Howard County  
Health Department

**ONSITE SEWAGE DISPOSAL SYSTEM**

PROPERTY ADDRESS: 5620 DOSA COURT, CLARKSVILLE, MD 21029

### ONSITE SEWAGE DISPOSAL SYSTEM PLAN

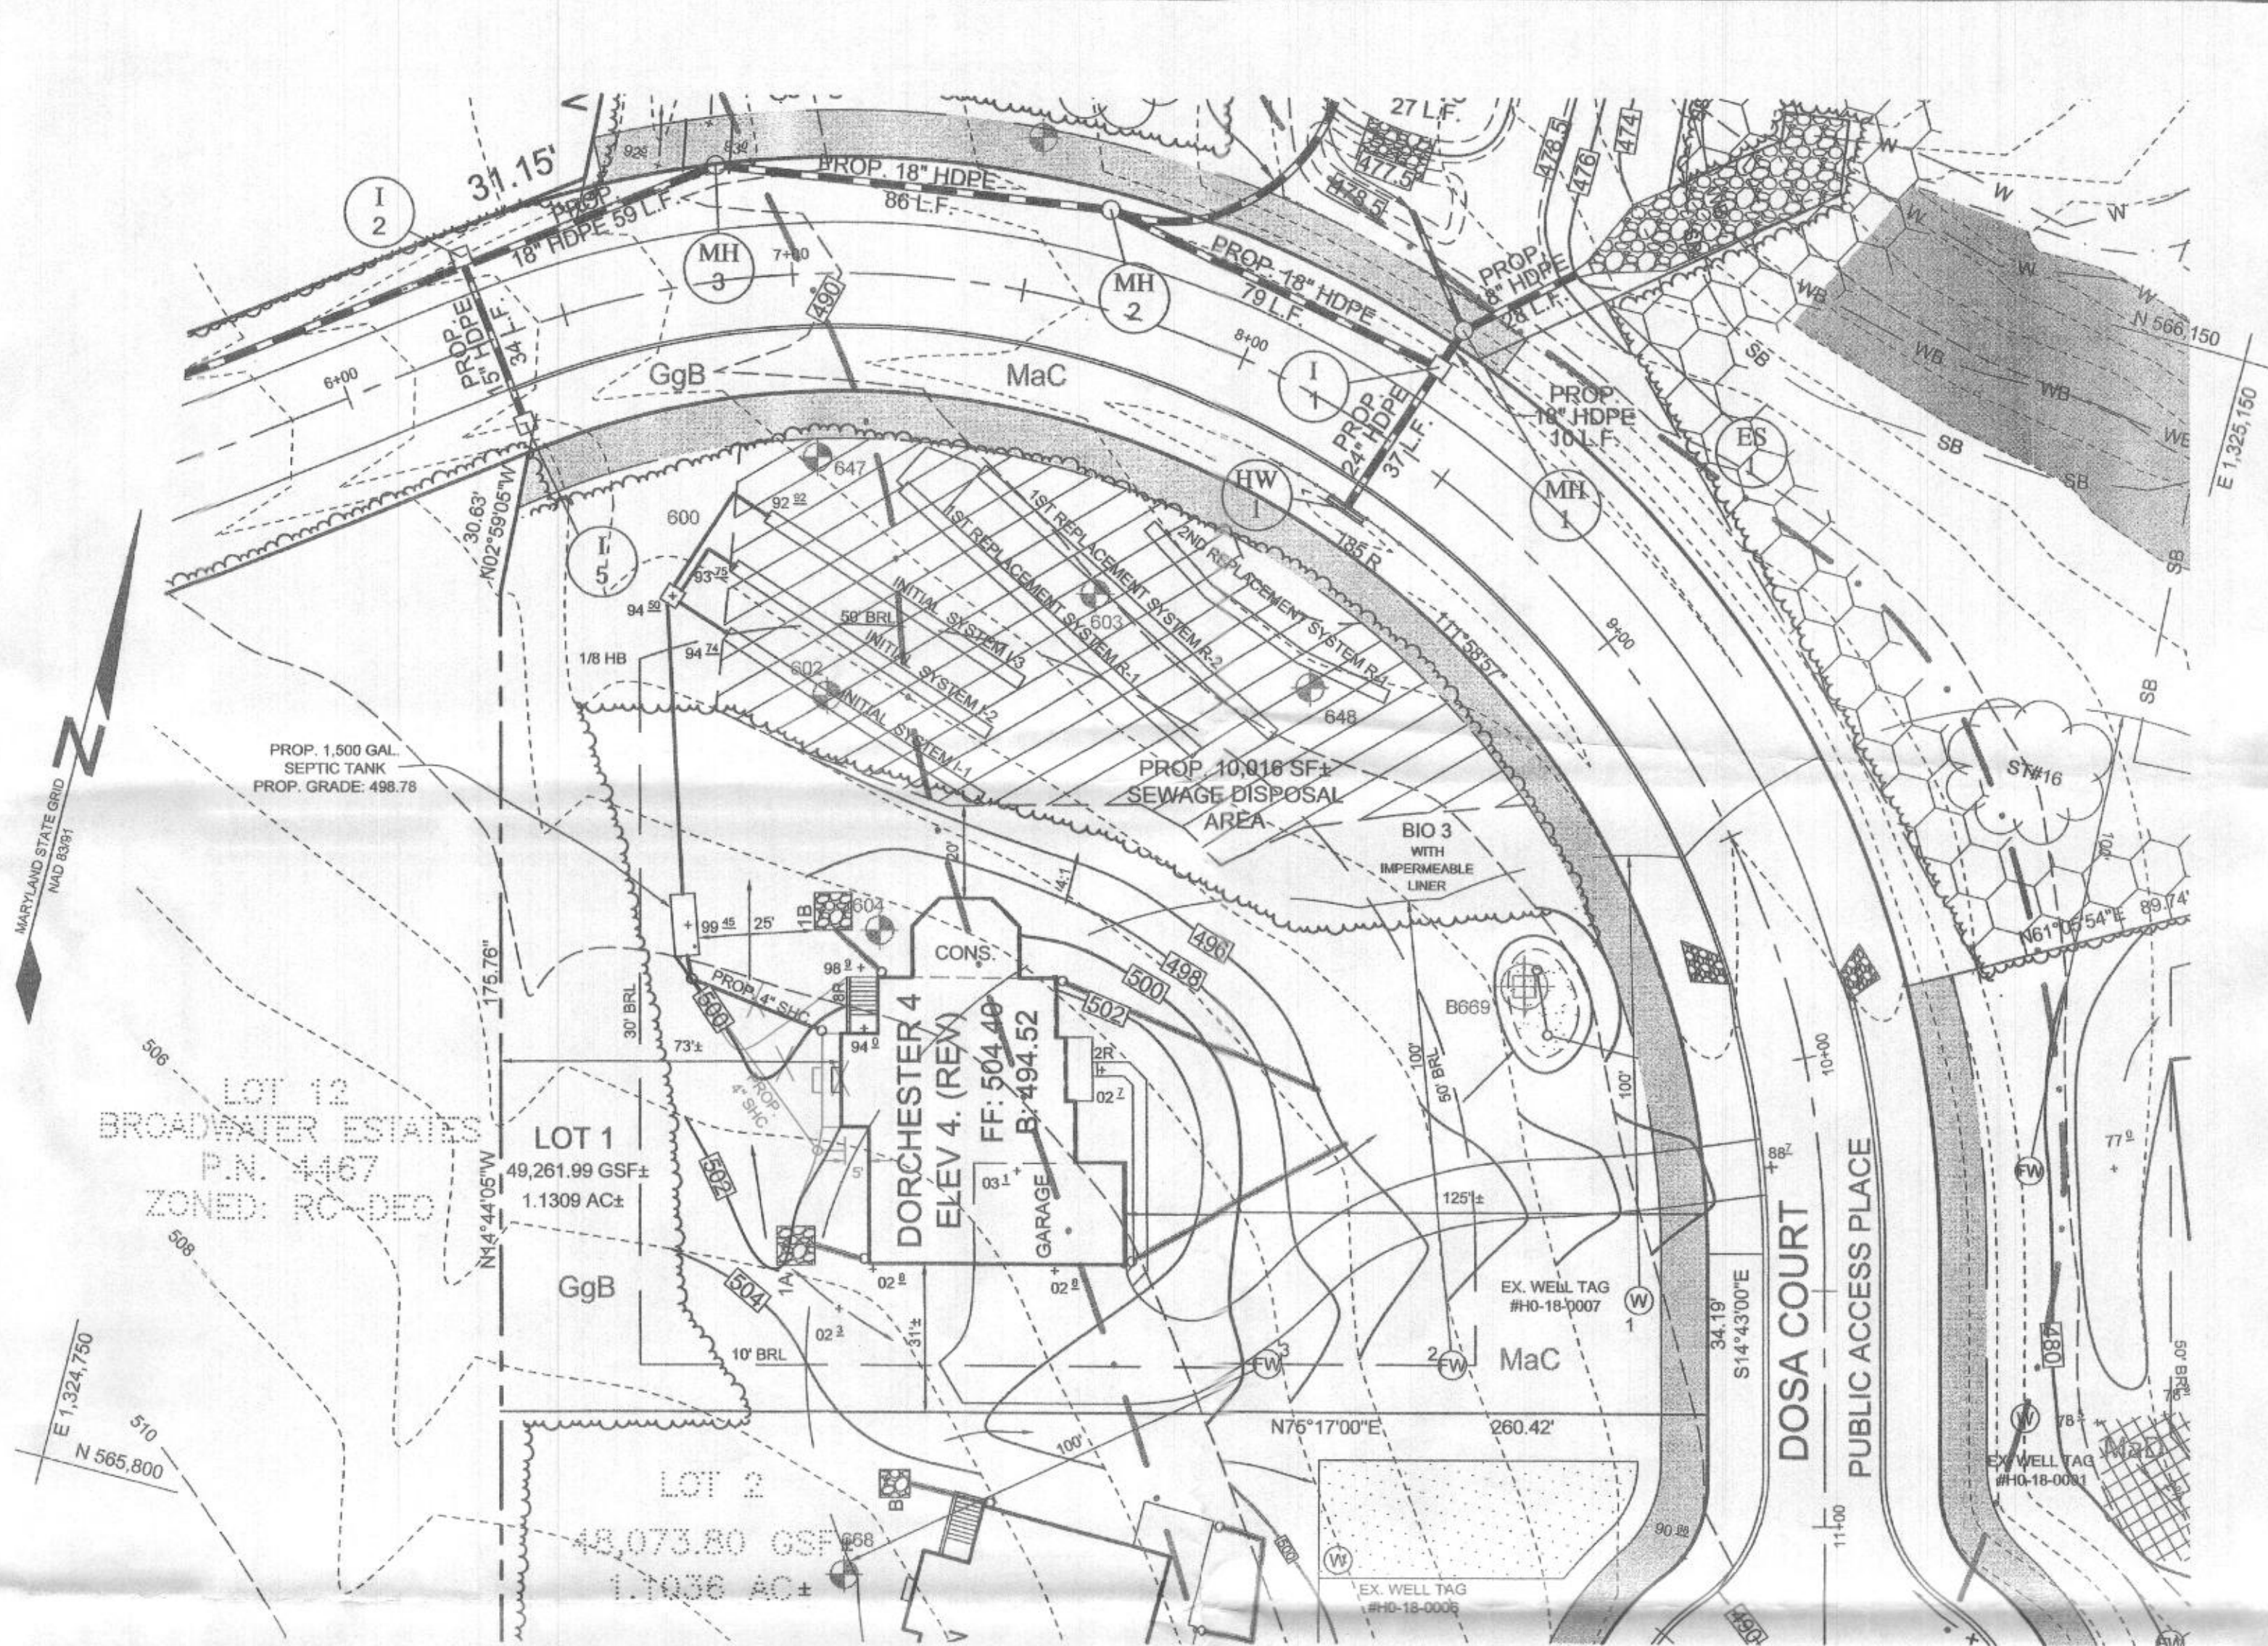
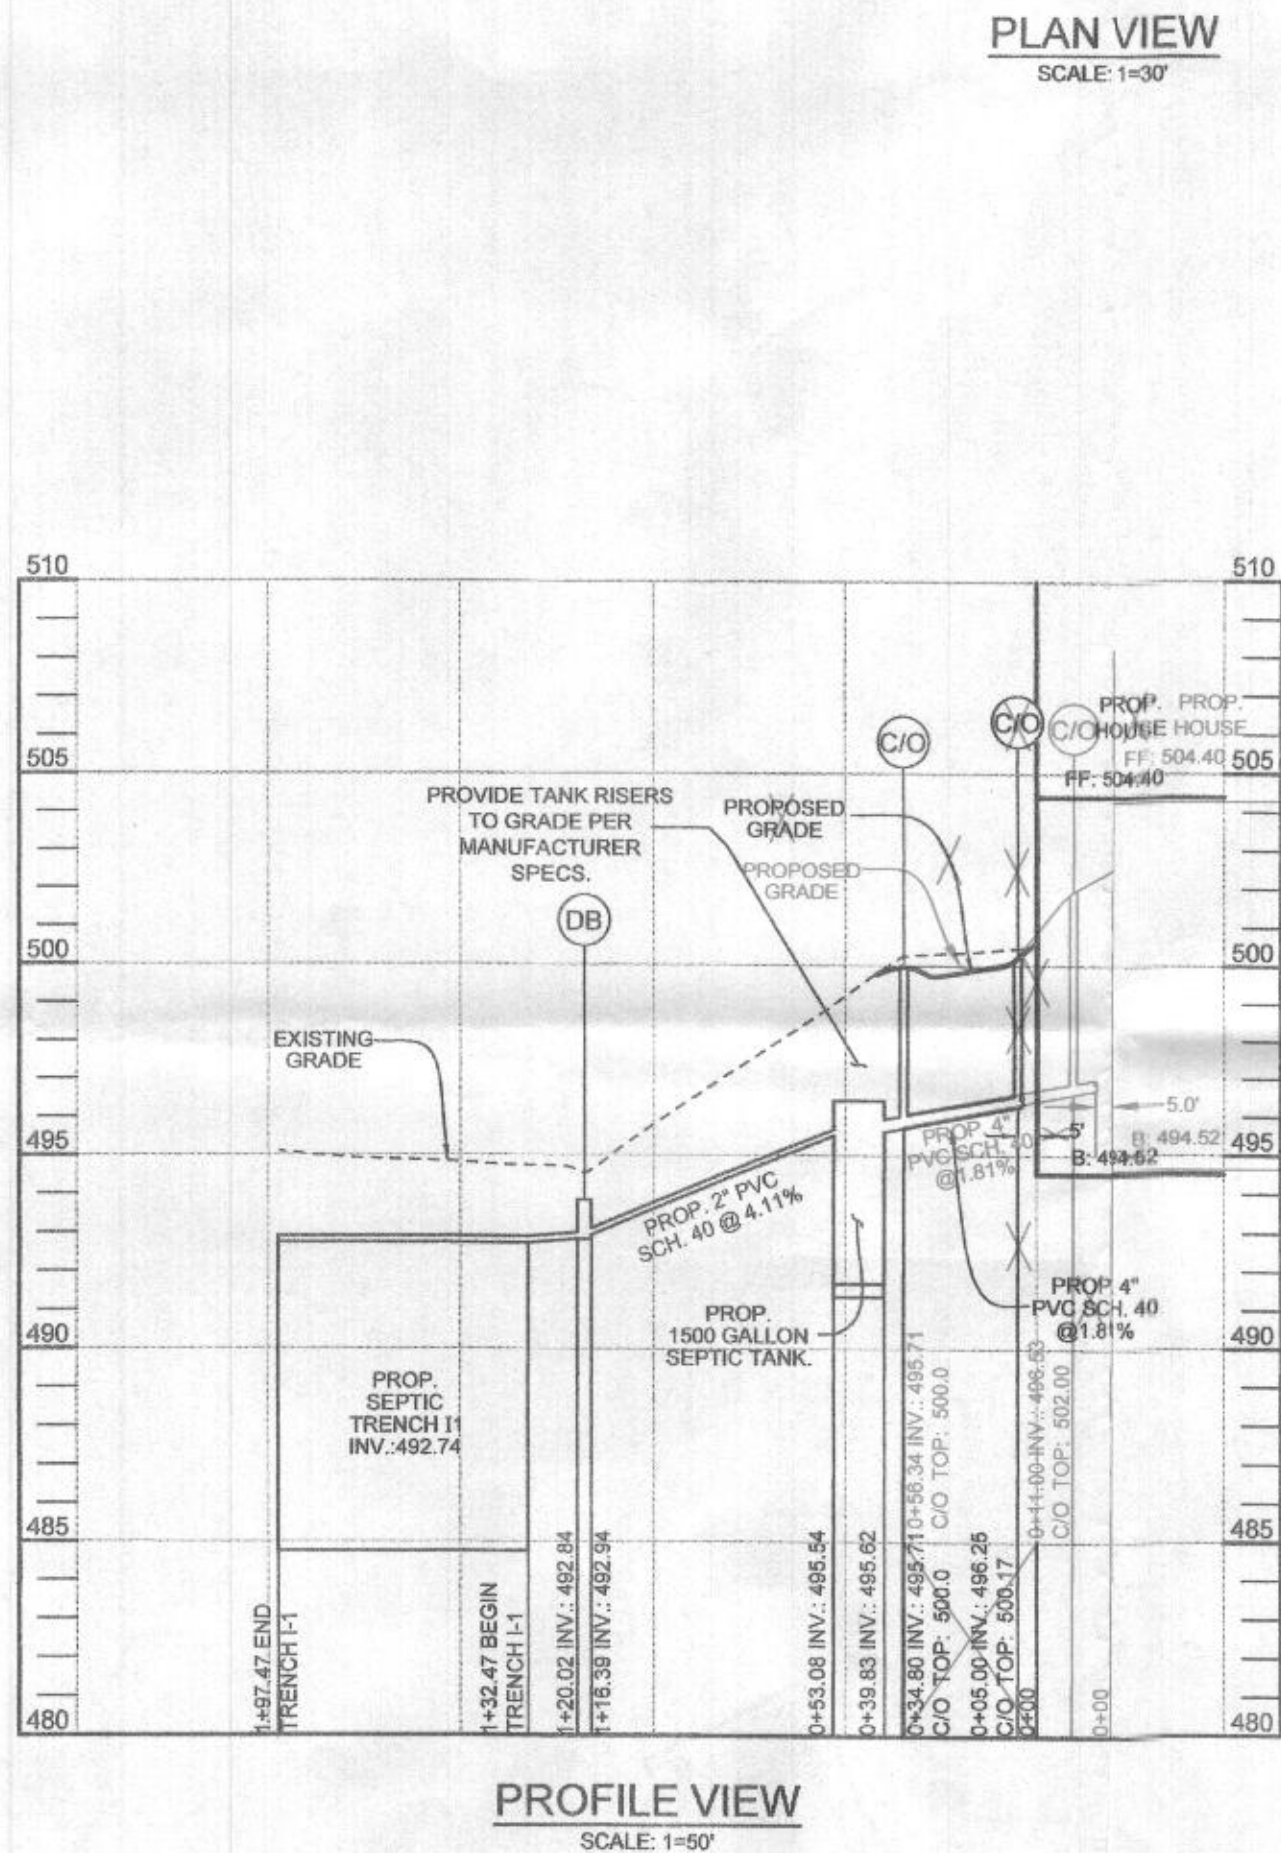
redline correction for  
SHE location. OK' MB  
4/28/21

### ONSITE SEWAGE DISPOSAL SYSTEM PLAN THE WOODLANDS 5620 DOSA COURT, LOT 1

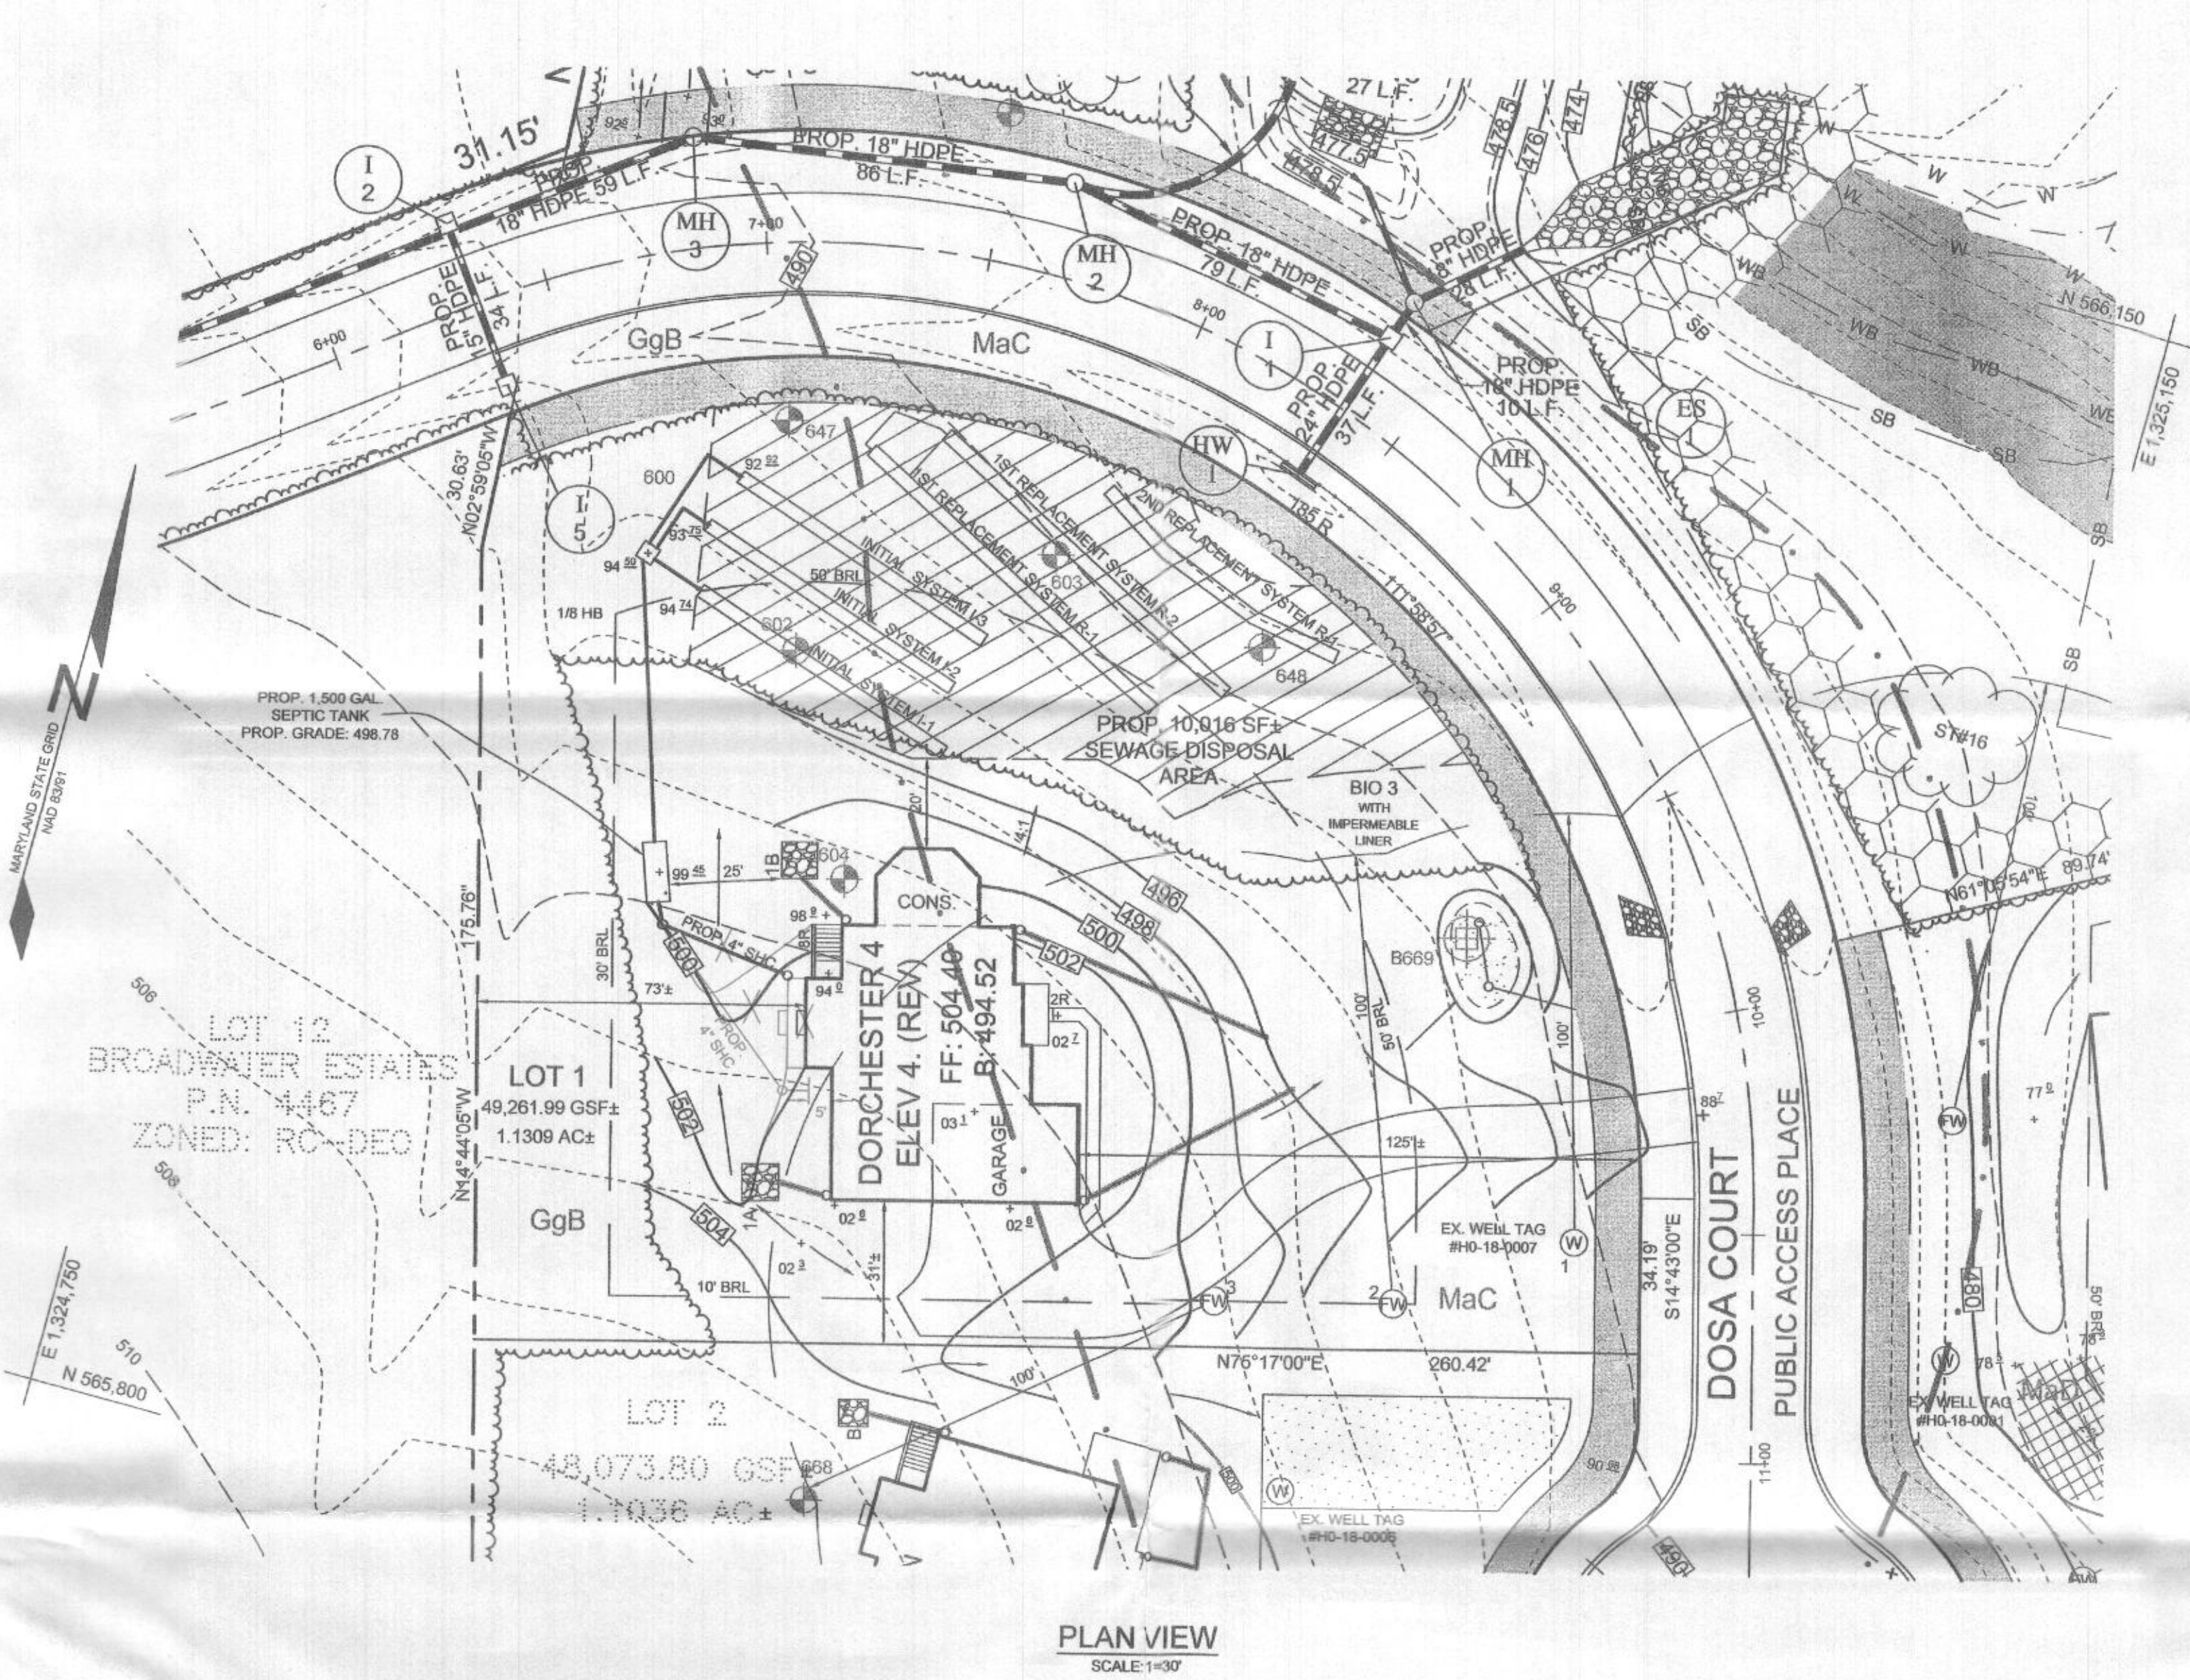
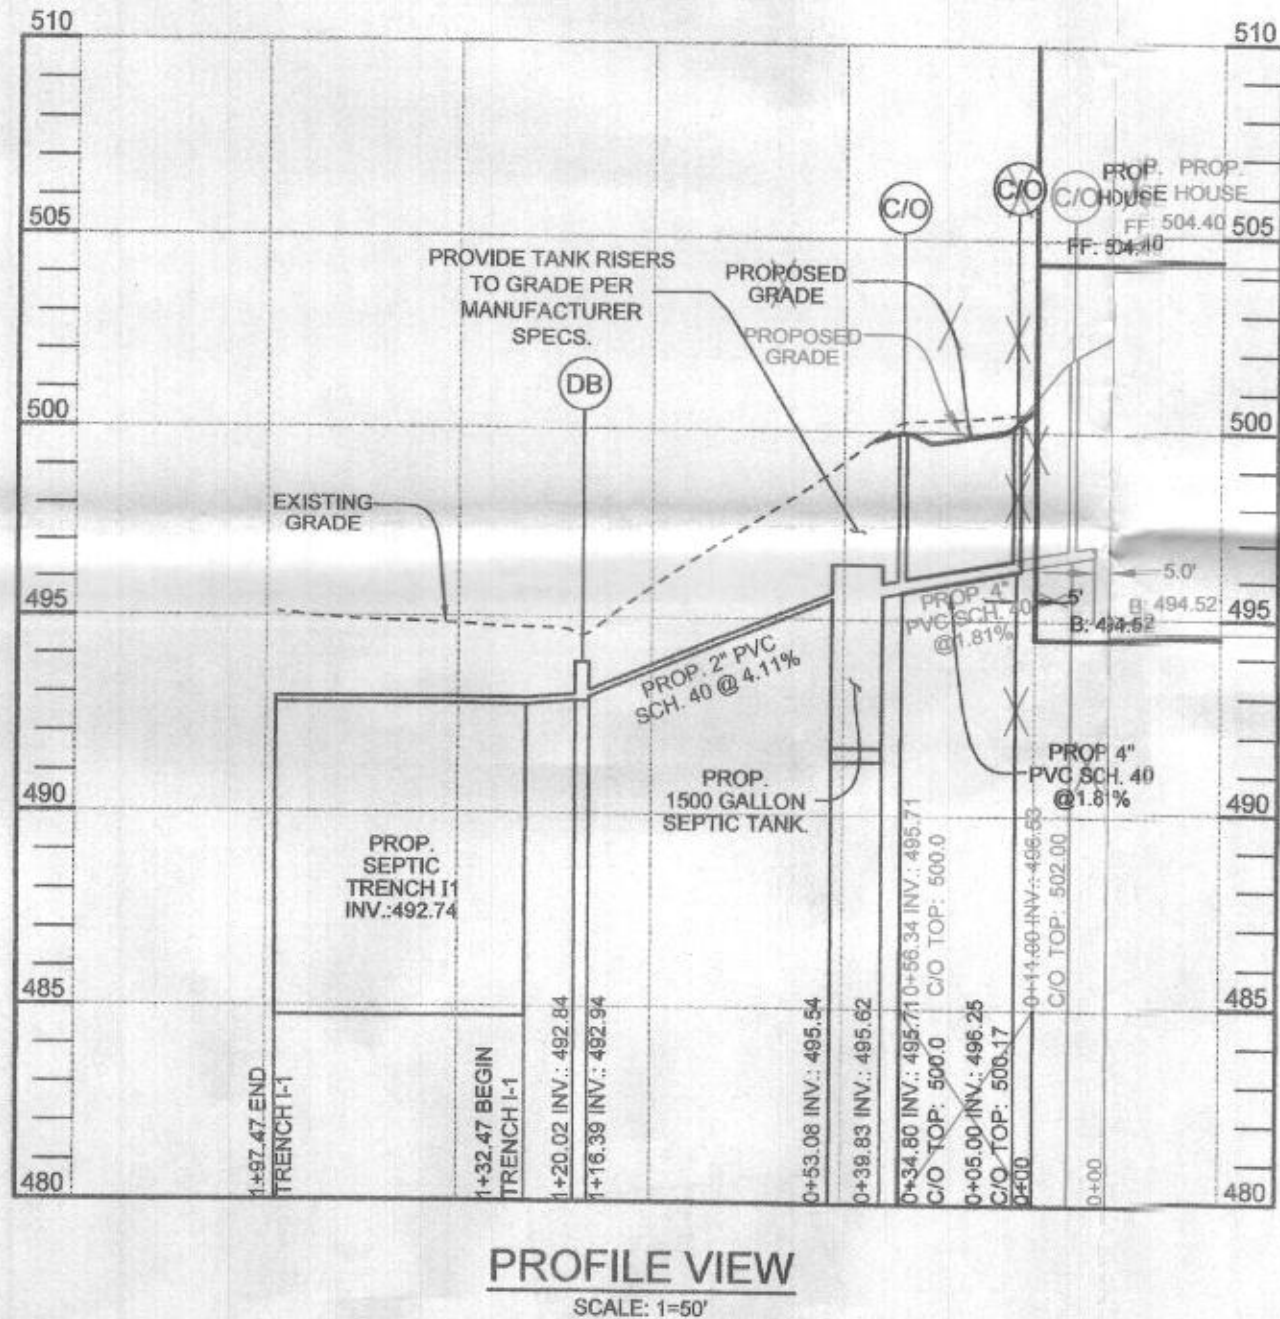
redline correction for  
SAC location. OK reB 4/28/21
